# HISTORIC AND DESIGN REVIEW COMMISSION

May 05, 2021

**HDRC CASE NO:** 2021-179  
**ADDRESS:** 506 E PARK AVE  
**LEGAL DESCRIPTION:** NCB 397 BLK 28 LOT 3 & E 1-2 OF 2  
**ZONING:** RM-4, H  
**CITY COUNCIL DIST.:** 1  
**DISTRICT:** Tobin Hill Historic District  
**APPLICANT:** Erin Camp/CAMP ERIN & COPPOLA KEVIN  
**OWNER:** Erin Camp/CAMP ERIN & COPPOLA KEVIN  
**TYPE OF WORK:** Driveway and front walkway modifications  
**APPLICATION RECEIVED:** April 05, 2021  
**60-DAY REVIEW:** Not applicable due to City Council Emergency Orders  
**CASE MANAGER:** Rachel Rettaliata

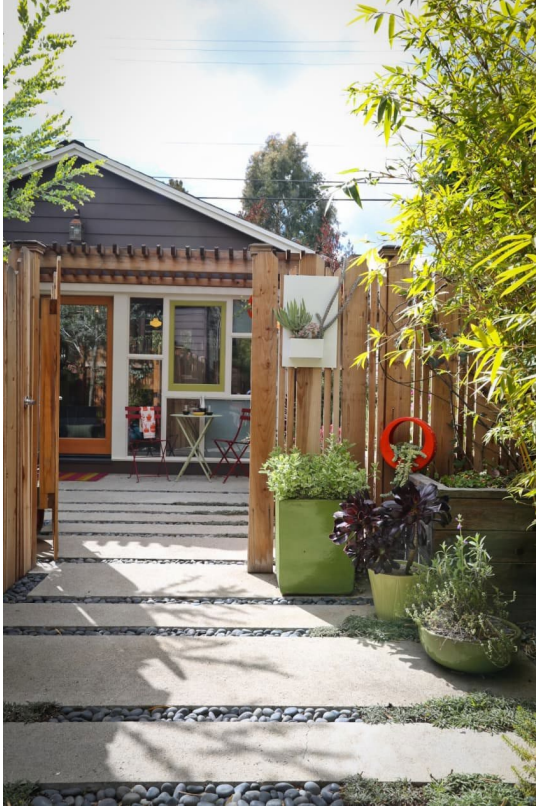
When re-landscaping, we had to pull out the already deteriorating brick walkway which we understand was installed around 2009. We would like to re do the walkway so that it is rectangular concrete pavers that showcase the wide front stair case on the front of the house. Currently, the walkway is much more narrow than the stairs and the rosebushes that were there were dangerous and partially obstructed the front stairs, hiding the architecture of the house from view.<sup>1</sup>

We would like to install concrete pavers in place of the brick walkway in the general style of the following examples:

Each paver would be the same width of the front stairs and would be evenly spaced from the other pavers. We would then either put gravel that matches our neighbor's or would attempt to plant grass in between each paver as demonstrated in the first two examples.

Additionally, we would need to demo a portion of the driveway, making it more narrow, so that the pavers can be the appropriate width and match the stairs off the front porch.

Item 2, staff does not recommend approval of the concrete paver installation based on finding c. Staff recommends that the applicant repairs and replaces the existing brick walkway with in-kind material or installs a fully concrete walkway to match the existing footprint.
